HIROSE ELECTRIC CO., LTD.

Product Change Notification

■Product list PCN2022-20_SR30 series specifications changed (Spacer deleted)

(Attachment 2) About the changes

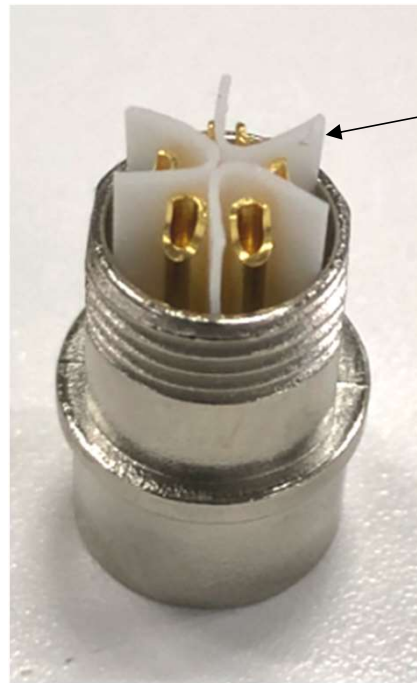
*1 The red marking that used to indicate the position of the terminal hole (for terminal No. 1) on the insulator will also be eliminated.

Eliminates the spacers that used to be placed between adjacent terminals.
